#### 49 CFR Parts 564 and 571

### Replaceable Light Source Information; Federal Motor Vehicle Safety Standards; Lamps, Reflective Devices and Associated Equipment

**ACTION:** Final rule.

**FIGURE 8 - BULB DEFLECTION TEST**

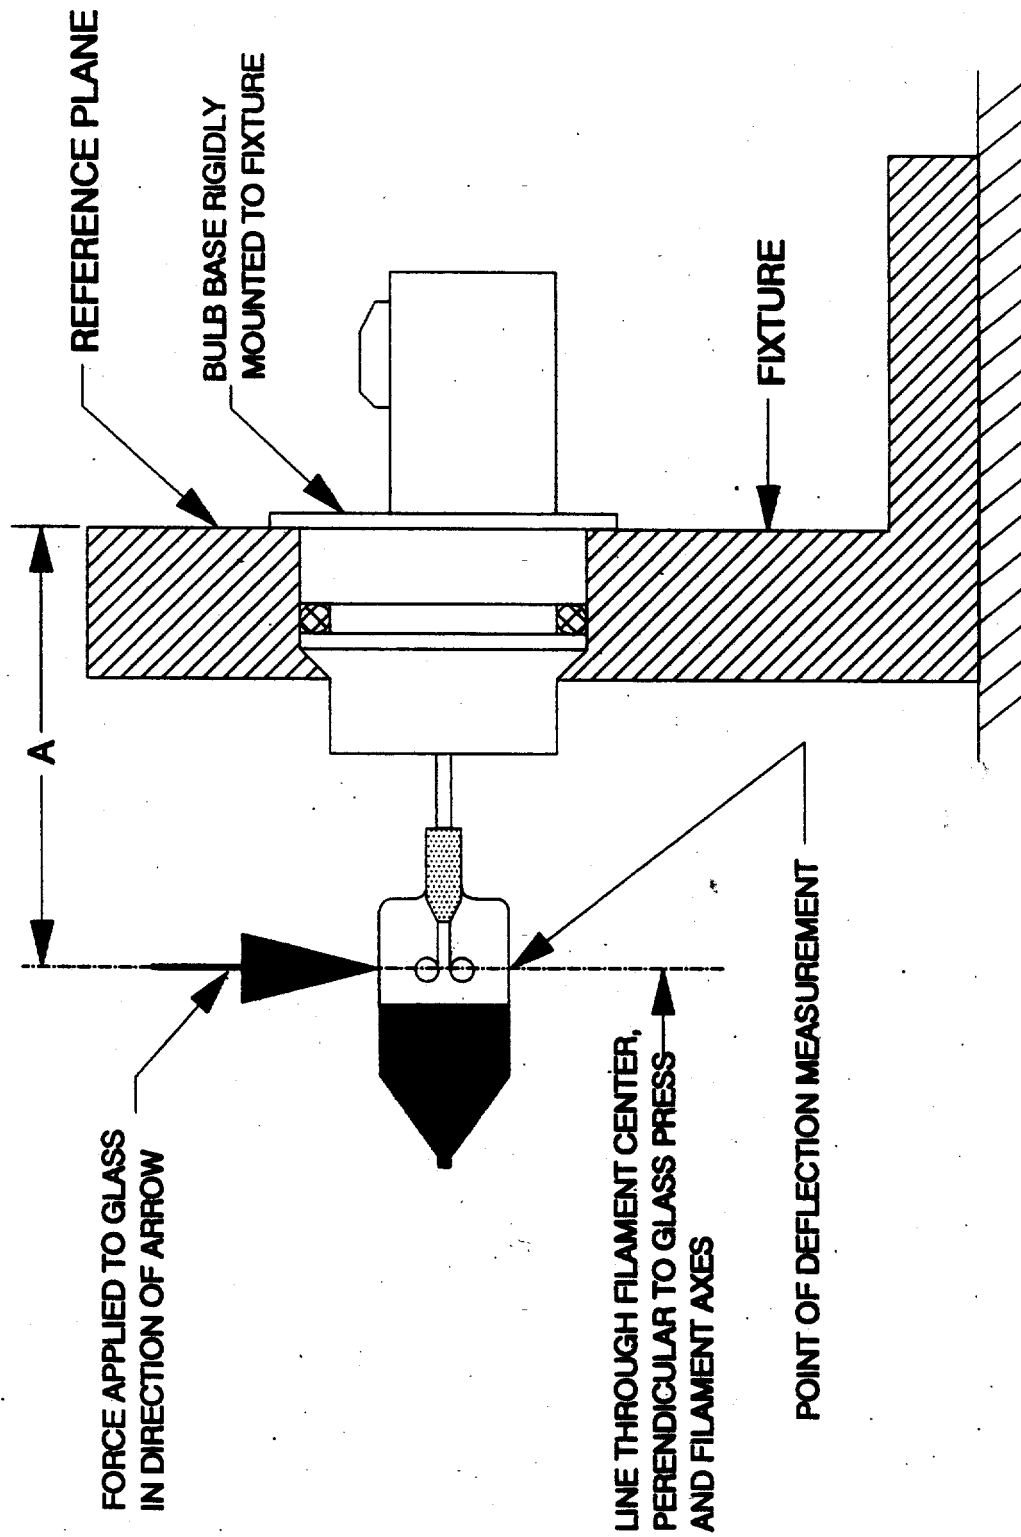
In addition, AAMA brought to the agency's attention that the proposed revision to Figure 8 did not identify Distance "A" referenced in Section S9. Figure 8, as adopted, will define the reference plane and Distance "A".

**S9 Deflection test for replaceable light sources.** \* \* \* Distance 'A' for a replaceable light source other than an HB Type shall be the dimension provided in accordance with Appendix A of part 564 of this chapter, section I.A.1 if the light source has a lower beam filament, or as specified in section I.B.1 if the light source has only an upper beam filament.

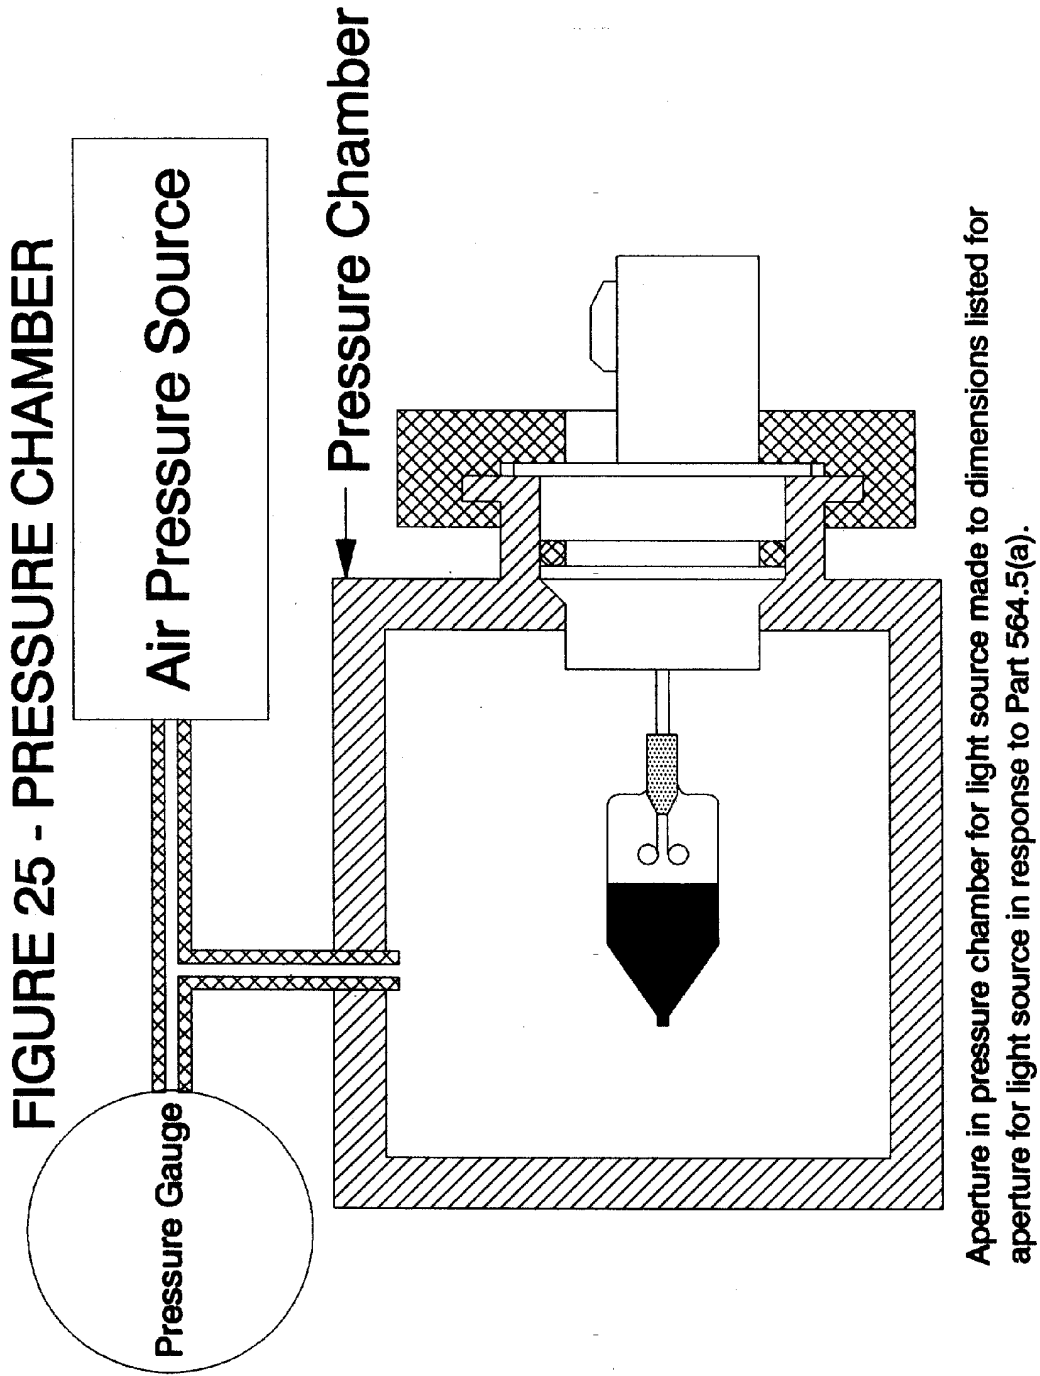
(c) The capsule, lead wires and/or terminals, and seal on each Type HB1, Type HB3, Type HB4, and Type HB5 light source, and on any other replaceable light source which uses a seal, shall be installed in a pressure chamber as shown in Figure 25 so as to provide an airtight seal. The diameter of the aperture in Figure 25 on a replaceable light source (other than an HB Type) shall be that figure furnished for such light source in compliance with Section IV.B of Appendix A of part 564 of this chapter. An airtight seal exists when no air bubbles appear on the low pressure (connector) side after the light source has been immersed in water for one minute while inserted in a cylindrical aperture specified for the light source, and subjected to an air pressure of 70kPa (10 P.S.I.G.) on the glass capsule side.
